UNITED STATES PATENT AND TRADEMARK OFFICE

APPLICATION NO.	FILING DATE	FIRST NAMED INVENTOR	ATTORNEY DOCKET NO.	CONFIRMATION NO.
10/065,357	10/08/2002	Hatem Belfadhel	121123-1	5645

Office Action Summary	Application No. 10/065,357	Applicant(s) BELFADHEL ET AL.	
	Examiner Terressa M. Boykin	Art Unit 1711

FIG. 1 is a schematic cross-sectional illustration that shows a condensate polishing ion exchange vessel utilizing the present invention.

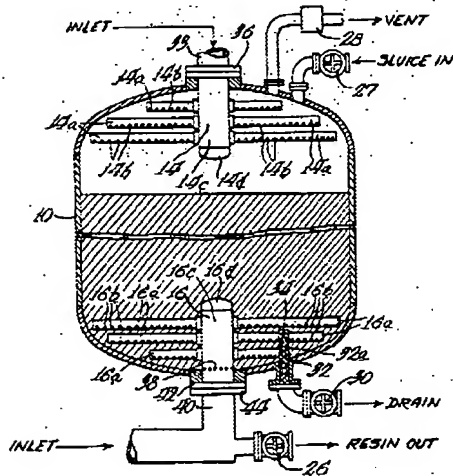
Claims 13, 17, 21 and 25 are rejected under 35 U.S.C. 102(b) as being anticipated by USP 3847805 see abstract, figure 1, cols. 4 –6 and claims 1, 2 and 3.

USP 3847805 discloses an ion exchange vessel containing ion exchange resin comprising a distribution means, liquid supply means connected to said distribution means for providing upward service flow, a collection means positioned above said distribution means, liquid supply means connected to said collection means for selectively providing downward liquid flow, said distribution means comprising unscreened apertured distribution means for both supplying said upward service flow and for removing resin from said vessel when said downward liquid flow is being selectively provided through said vessel and draining means comprising a screened lower drain for selectively draining liquid from said vessel without the removal of any substantial amount of resin from said vessel, said distribution means comprises a hollow hub which protrudes upwardly through the center of the bottom of said vessel and a plurality of hollow radially extending unscreened apertured laterals which are in

fluid communication with said hub, said hub having a plurality of unscreened holes therein which extend circumferentially around said hub adjacent the area where said hub protrudes through the bottom of said vessel.

Thus the reference and upflow reactor and distributor discloses a prepared from the same components as claimed by applicants. Thus in view of the above, there appears to be no significant difference between the reference and that which is claimed by applicant(s). Any differences not specifically mentioned appear to be conventional. Consequently, the claimed invention cannot be deemed as novel and accordingly is unpatentable.
